ADDENDUM NUMBER 8

- 1.01 DATE: APRIL 13, 2021
- 1.02 PROJECT: WELCOME CENTER
- 1.03 PROJECT NUMBER: DCM NO. 2020604
- 1.04 OWNER: ALABAMA A&M UNIVERSITY
- 1.05 ARCHITECT: NOLA | VAN PEURSEM ARCHITECTS, PC

SHEET TITLE	SECOND FLOOR PLAN
SHEET NUMBER	A-1.4
OF

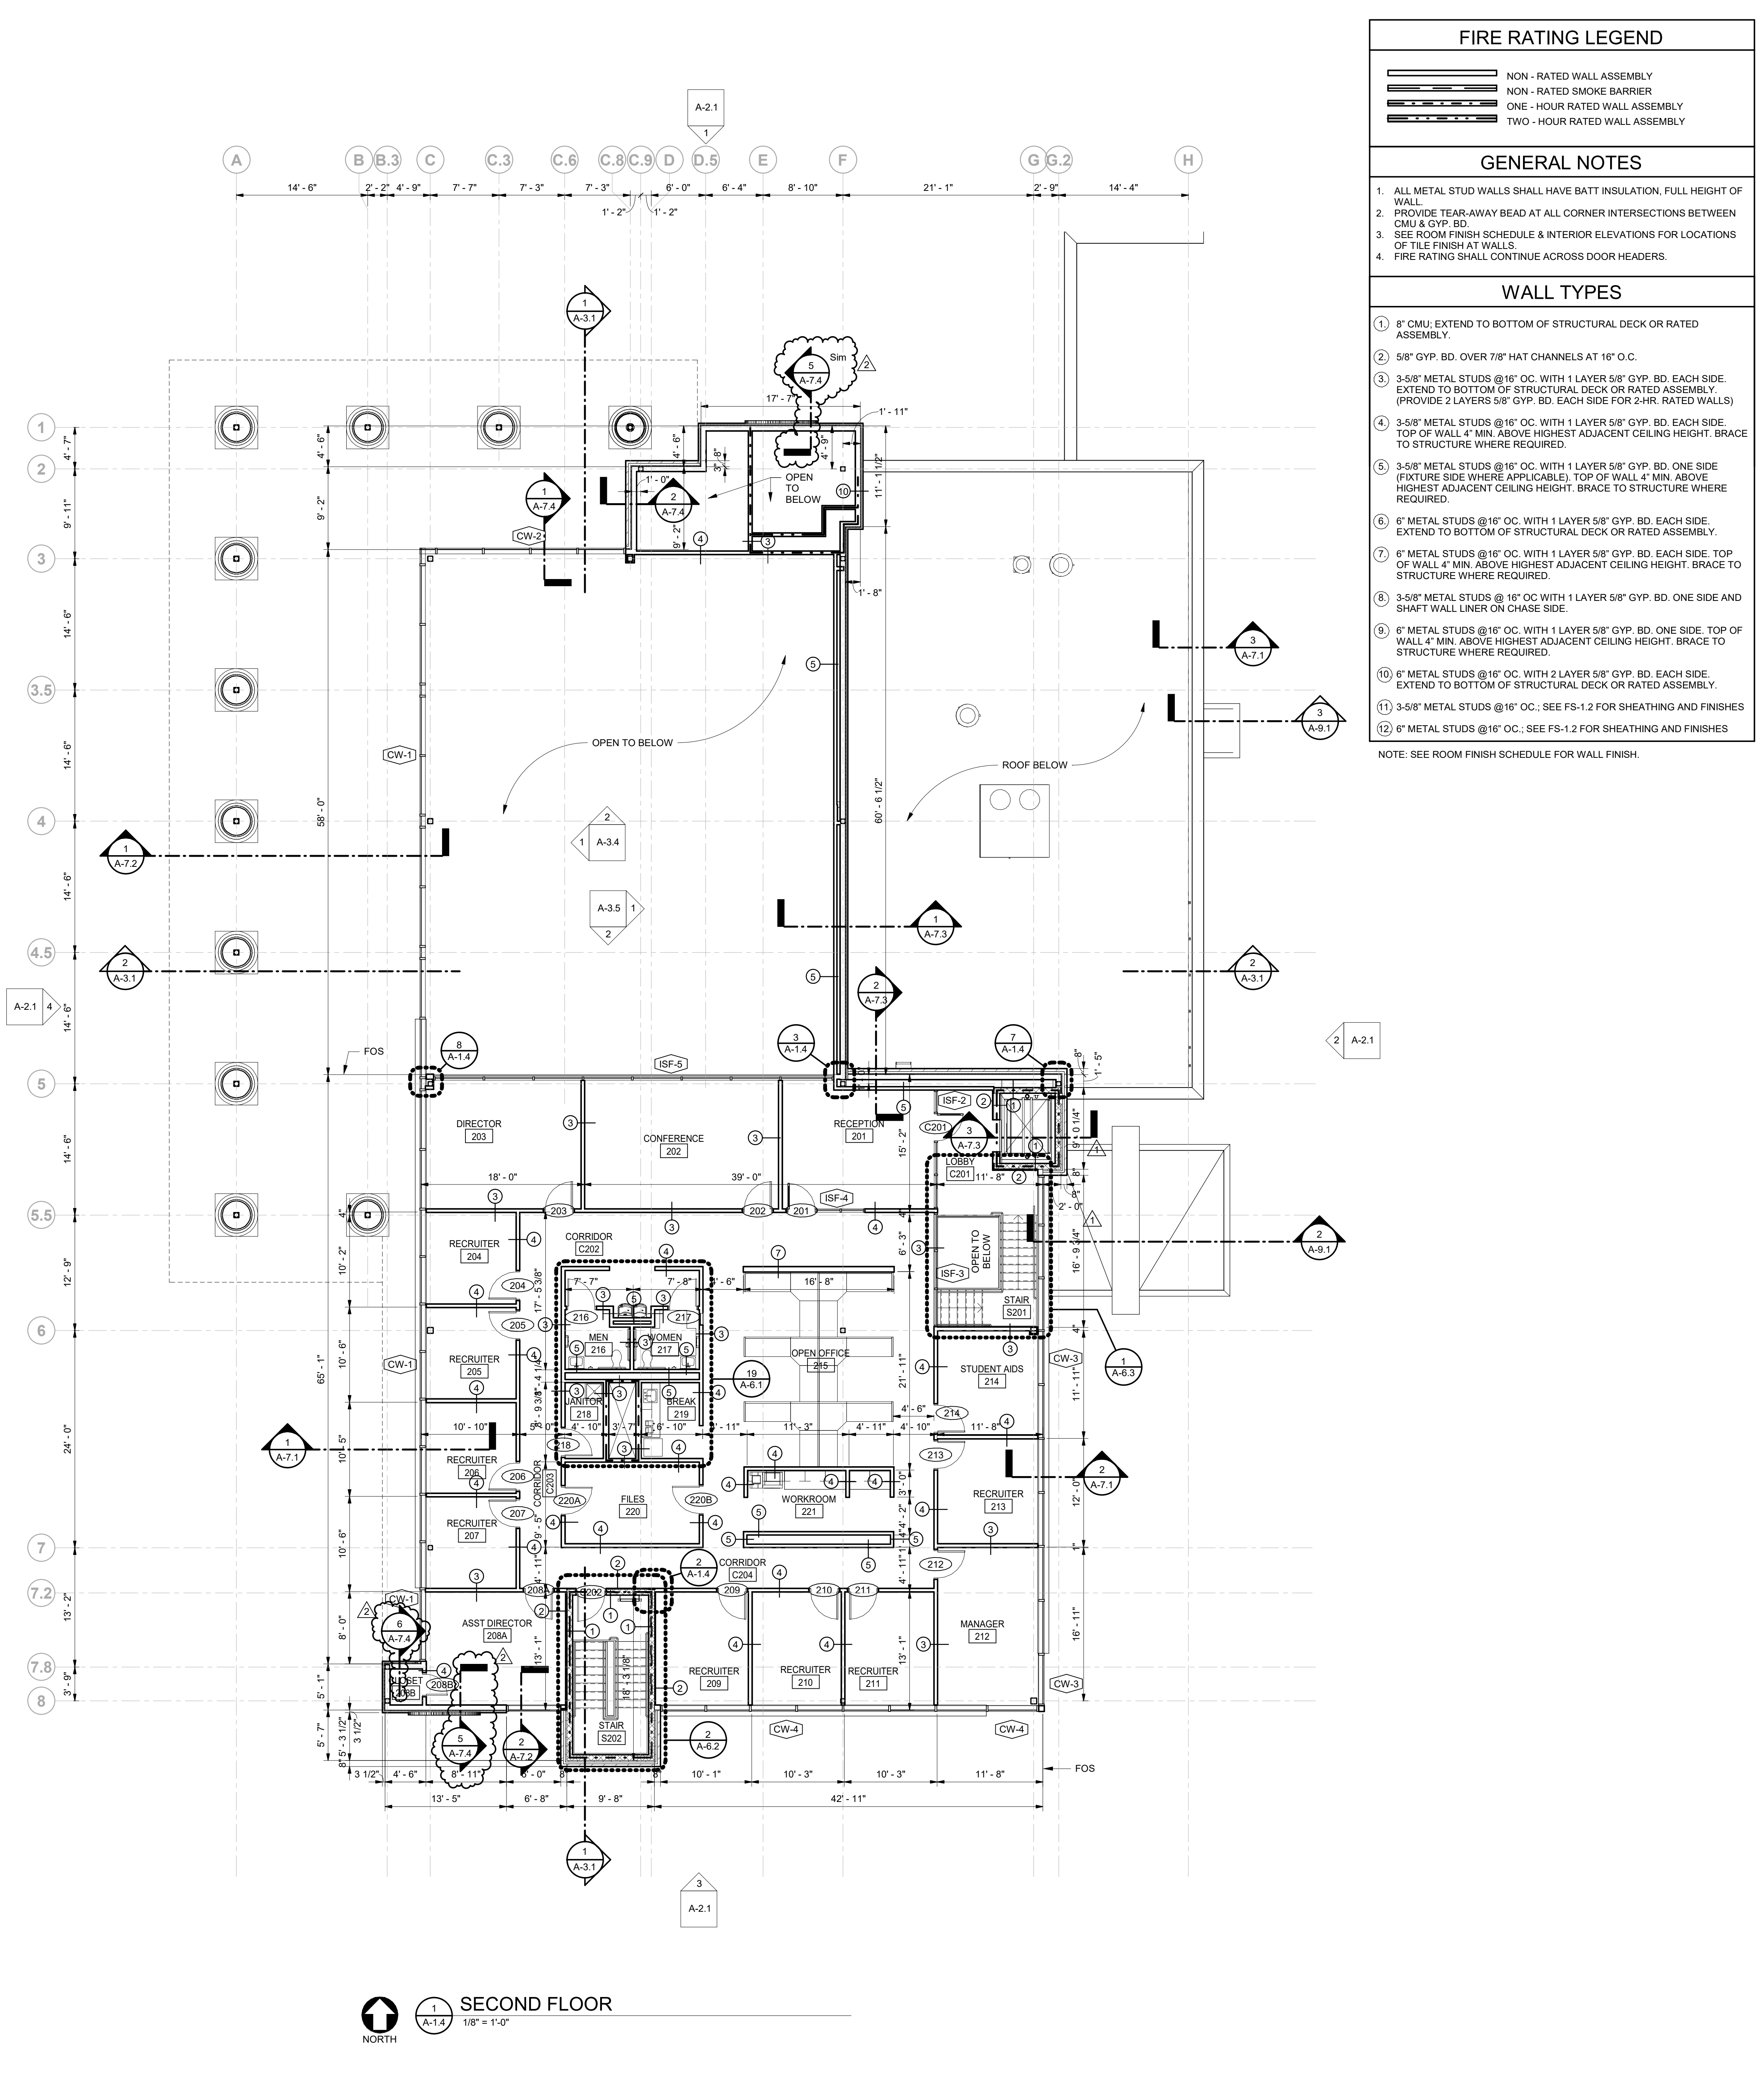
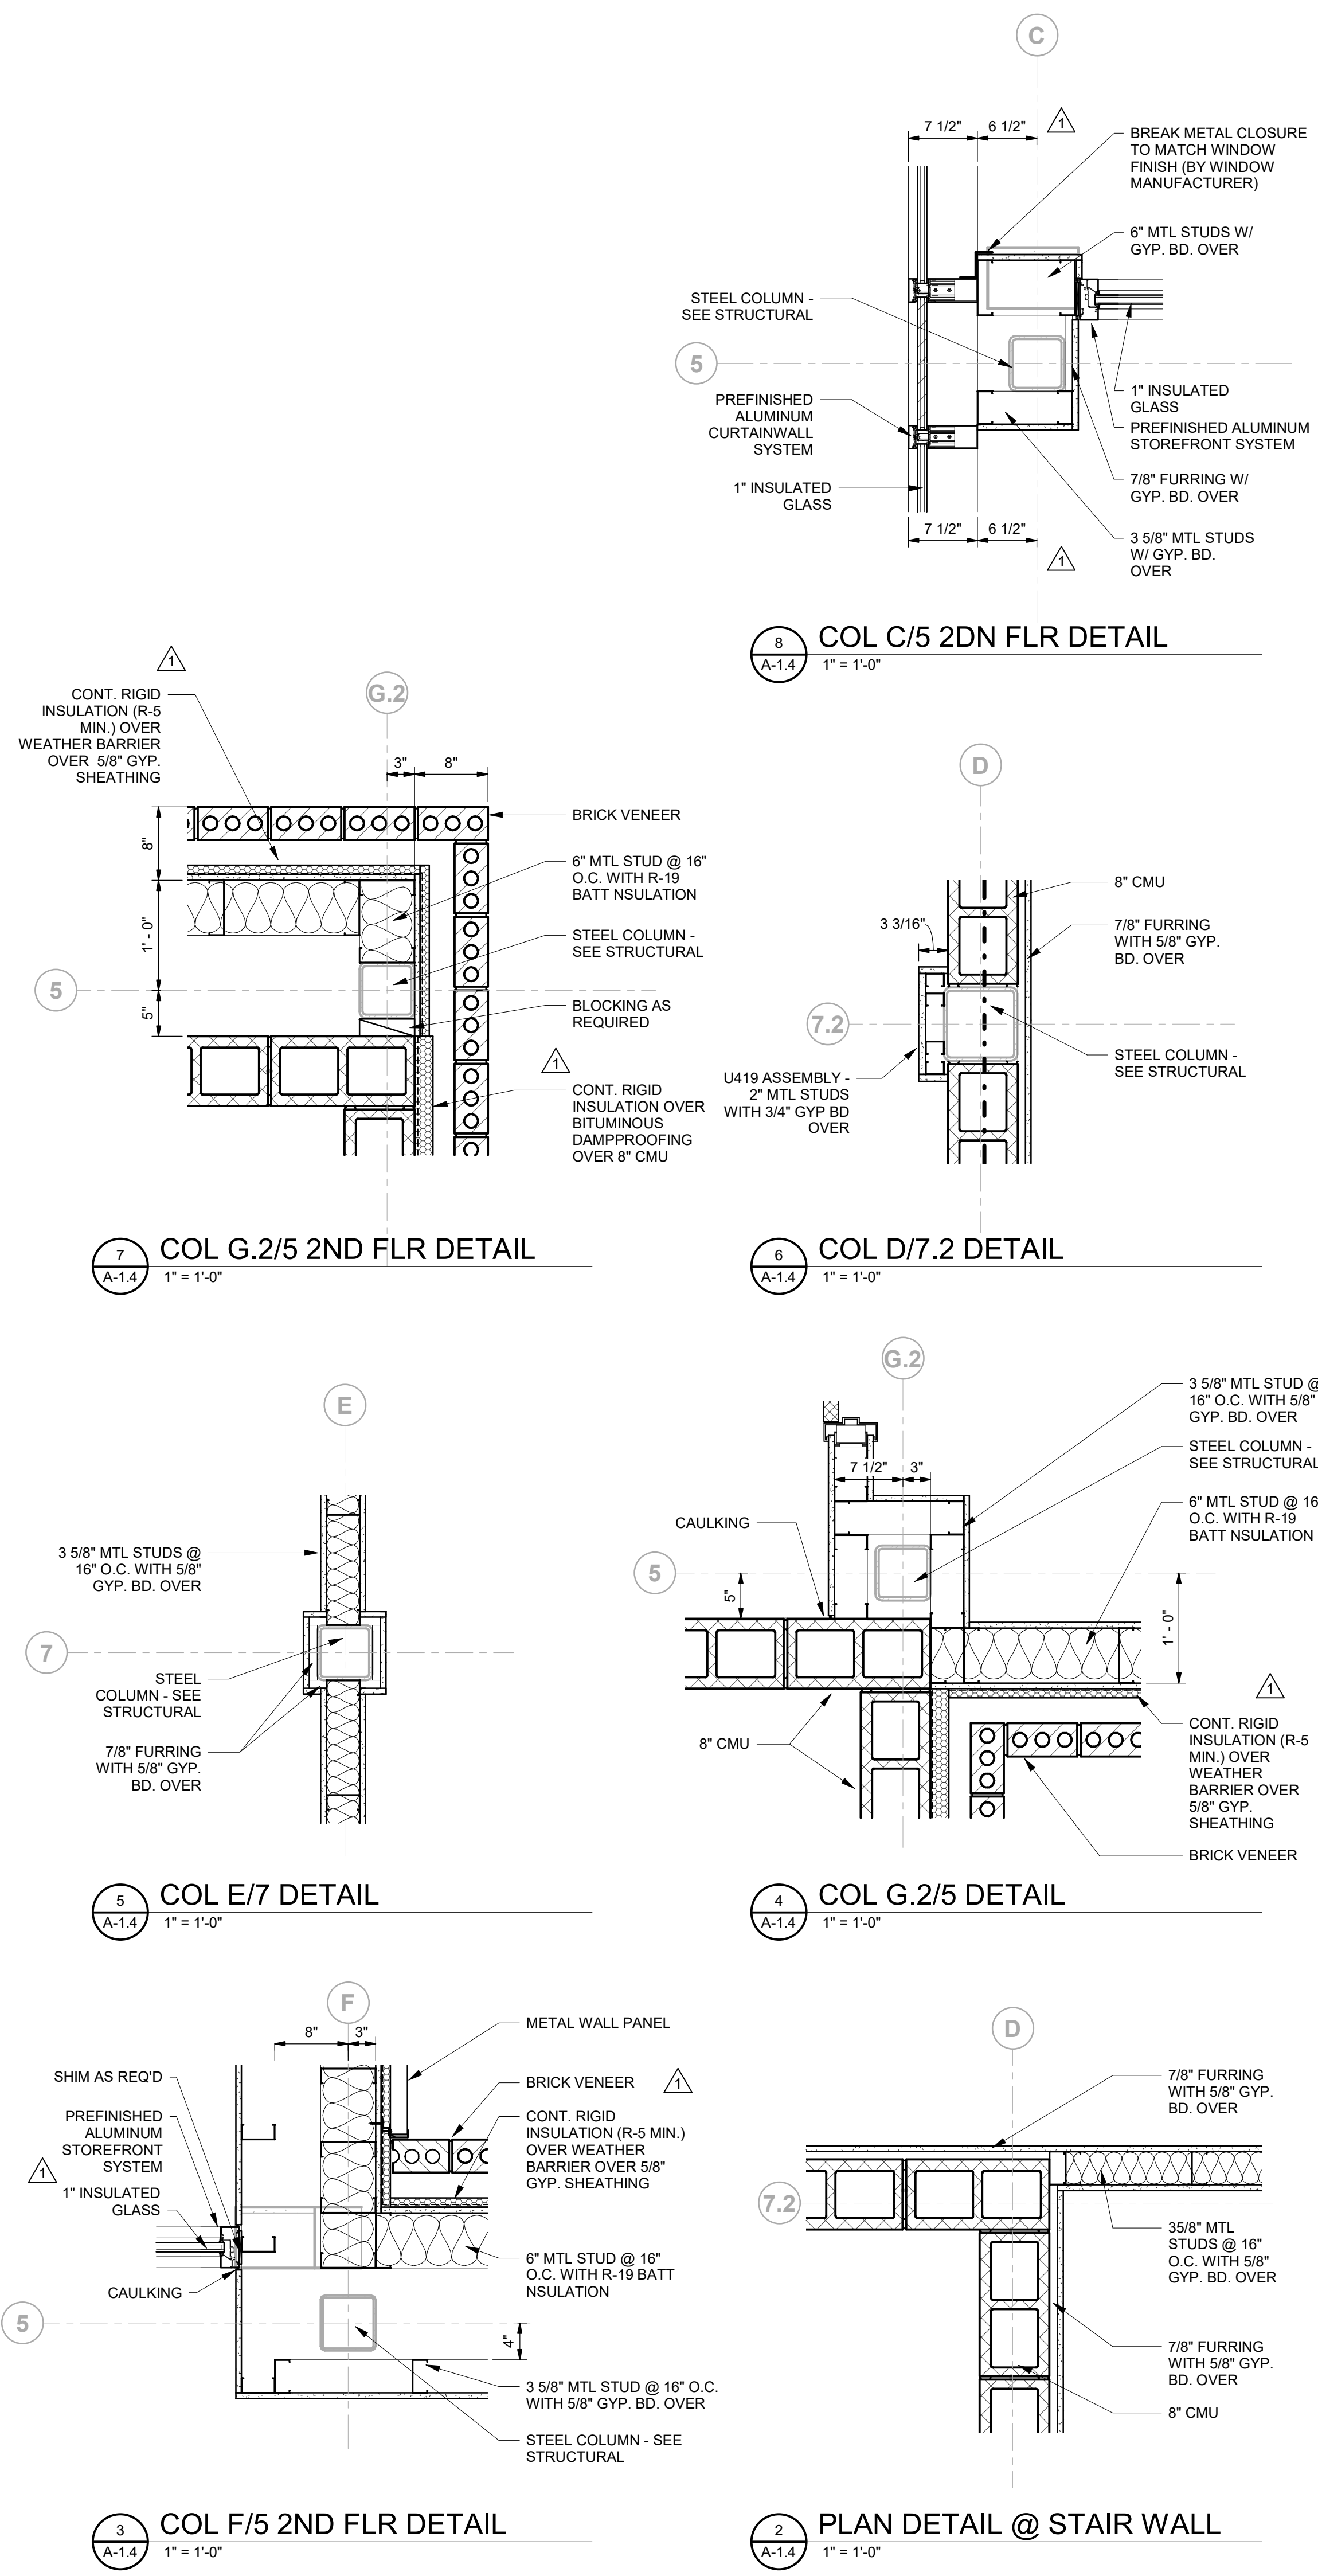
4.02 SHEET A-1.4 – SECOND FLOOR PLAN:

A. Replace this sheet in its entirety. Revisions include the following: Added wall section marks.
